Addendum 01

DOCUMENT 00 91 00

PROJECT: Shenandoah School Corporation New Transportation Center
5100 North Raider Road
Middletown, Indiana 47356

PROJECT #: 25107.00

1 FIRST FLOOR PLAN - UNIT A & B
1/8" = 1'-0"

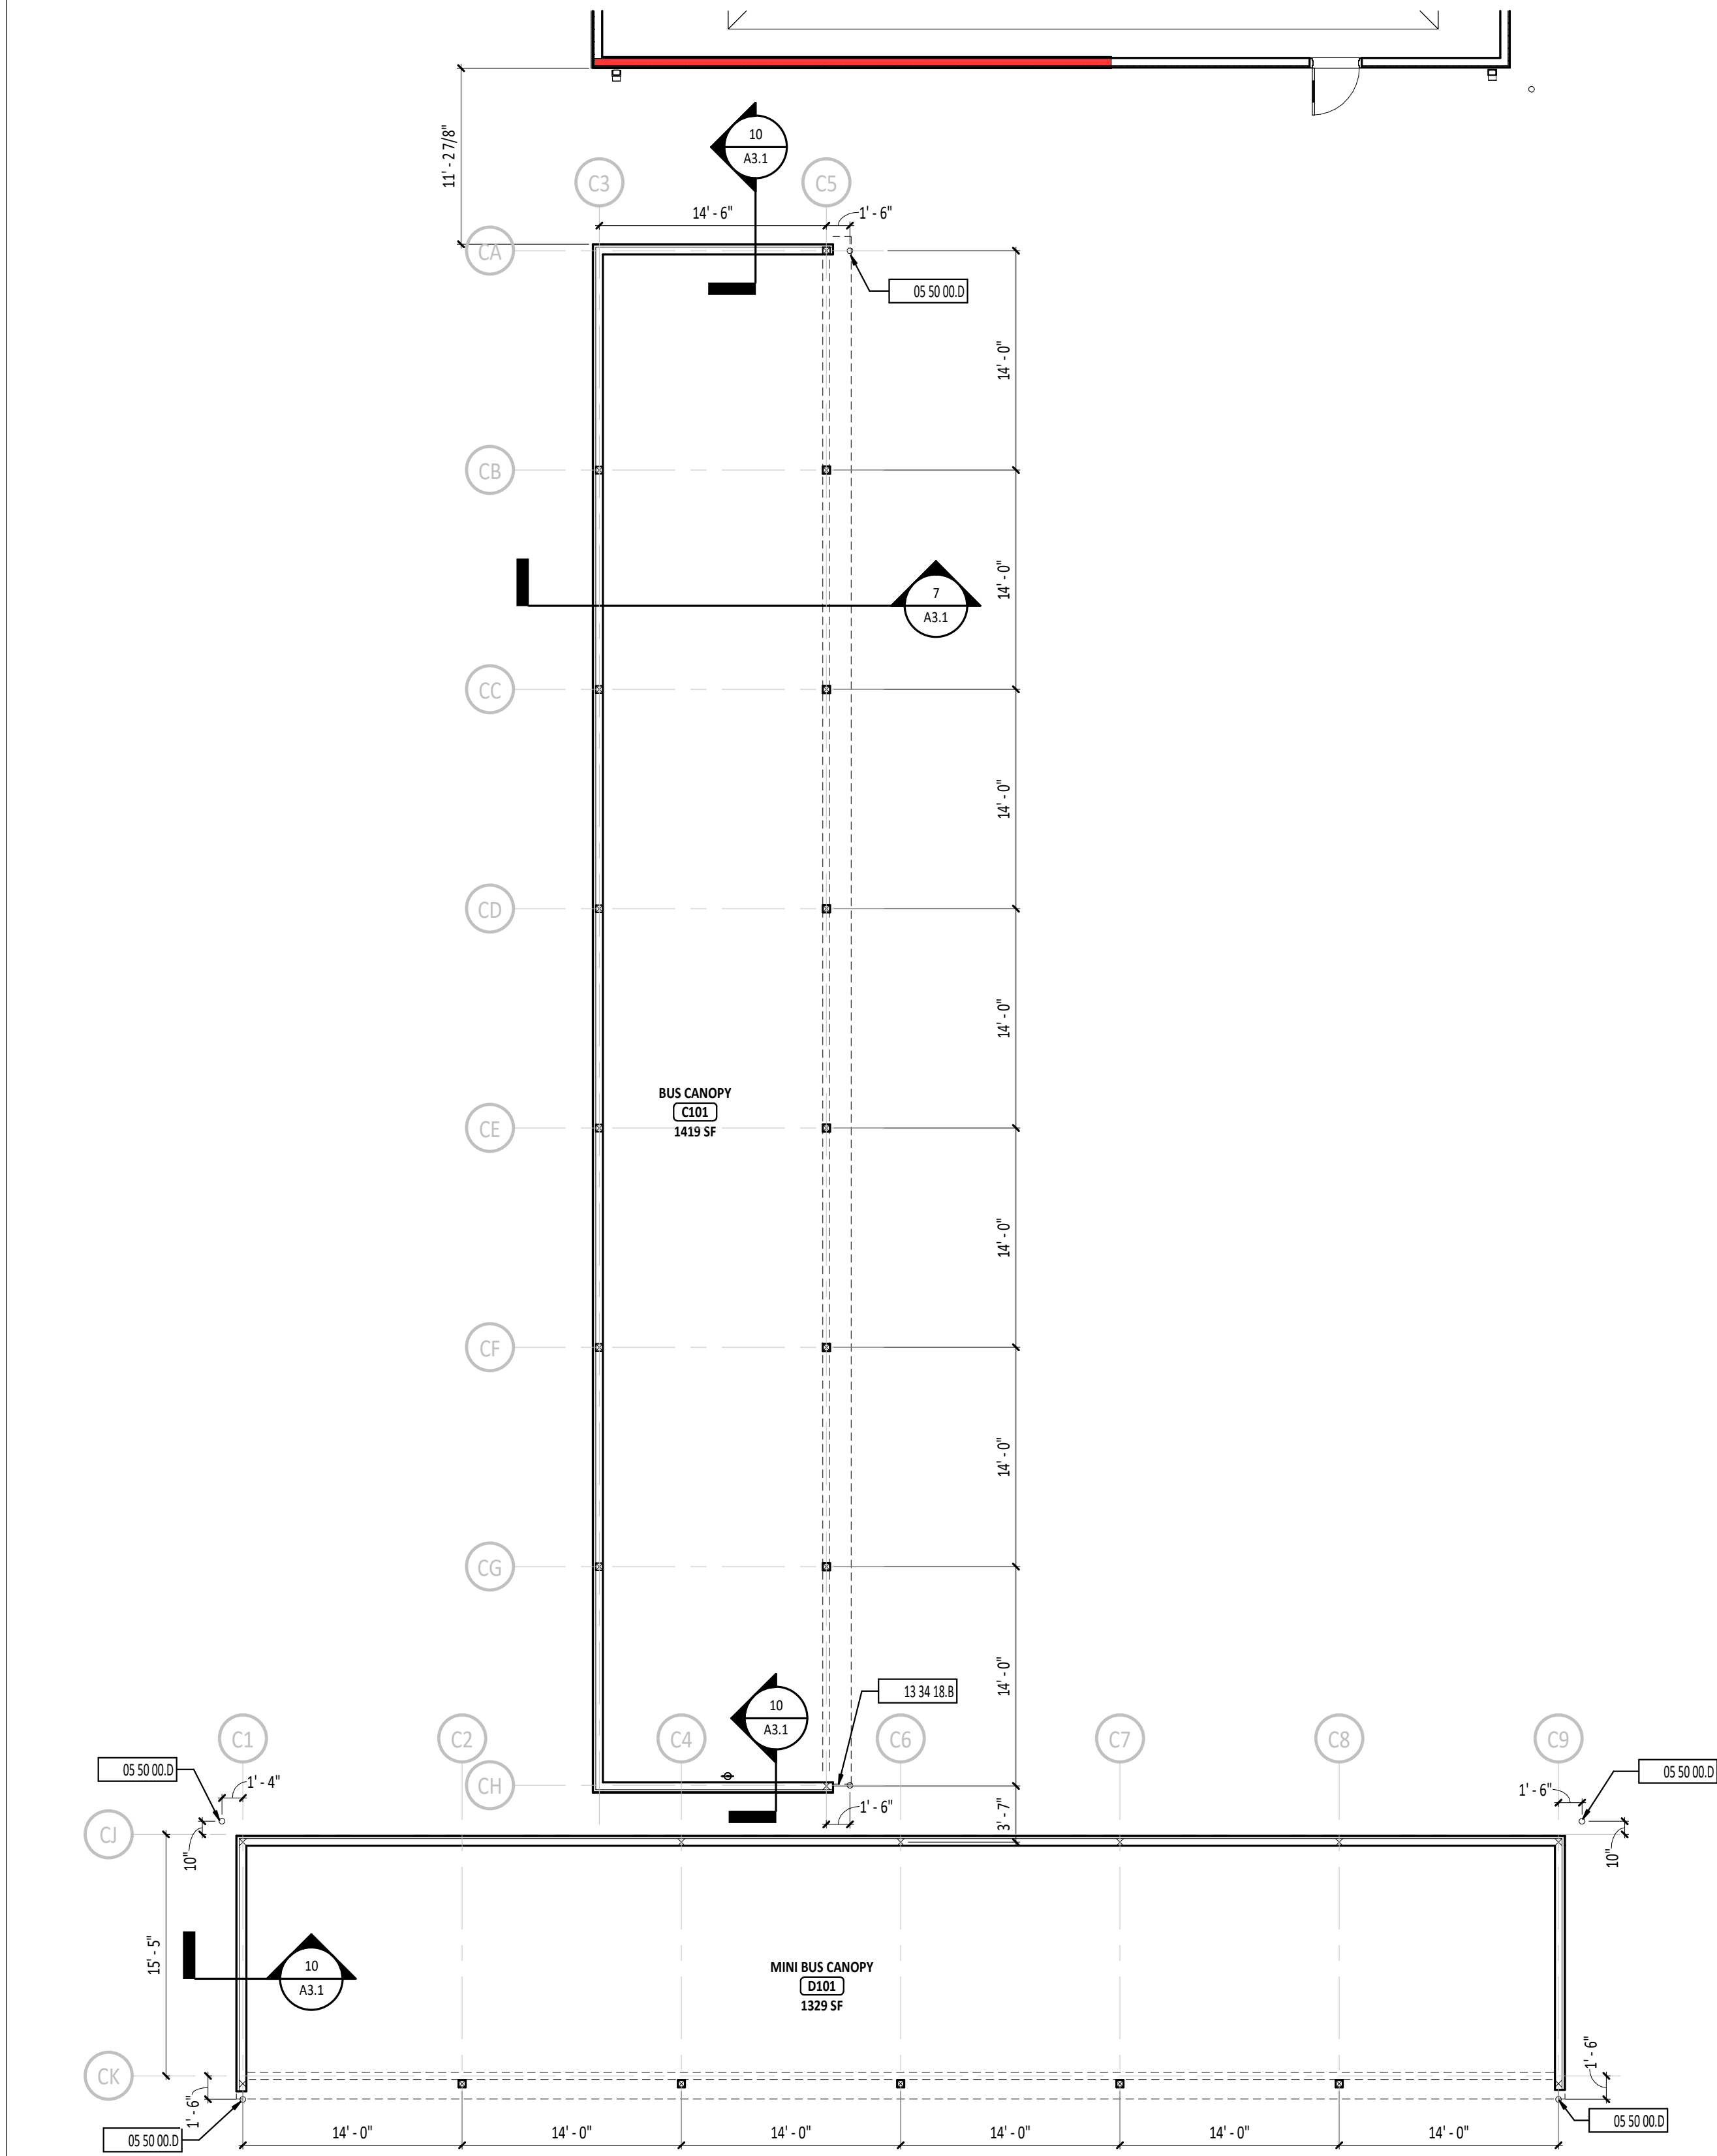
1. Drawing sheet A1.1
 - a. Revised concrete floor slopes to drain in the maintenance garage
2. Drawing Sheet P2.1
 - a. Revise depth of trench drains, to match slope in the maintenance garage.
3. Drawing Sheet S1.1
 - a. Revised the layout of the floor slopes in the maintenance bay.
